This Service Information bulletin supersedes SI B13 02 14 **dated September 2014.**

NEW N47T: Diesel Particulate Matter Sensor Faults Stored in DDE

F25 (X3 xDrive 28d)

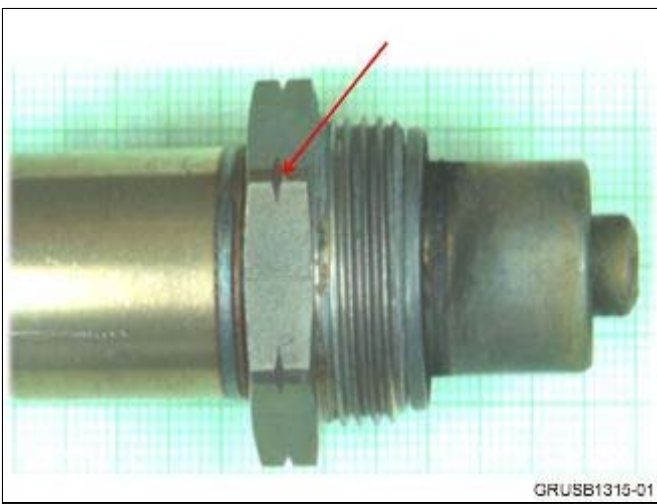
The PM sensor has been redesigned and was phased into production beginning 7/2014.

NEW The redesigned particulate matter sensor can be identified by the presence of notches in the union nut.

NEW Replace the PM sensor and program the vehicle using the latest version of ISTA/P.
